Product /Process Change Notification

PCN Number: PCN-202109290001

For more flexible and smooth production support and reduce shipment impact from current supplier, LITEON would add ChangeLight dice as 2nd source, keep the same performance, quality, and RA requirements. The action will implement at the end of November 2021.

Appendix 4

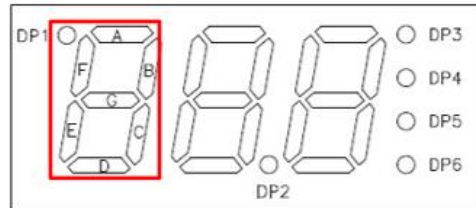
- Liteon PN : 02-KR-SS series
- Test with ND Display device : LTC-5685KR -S4
- Dice color : Super Red
- RA test meet QA spec.
 - Test result meet QA spec.
 - Dice performance are the same

Appendix 5

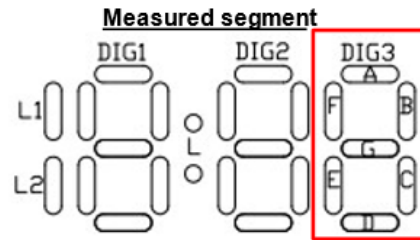
- Liteon PN : 02-KF-SS series
- Test with ND Display device : LTC-3698KF
- Dice color : Yellow Orange
- RA test meet QA spec.
 - Test result meet QA spec.
 - Dice performance are the same
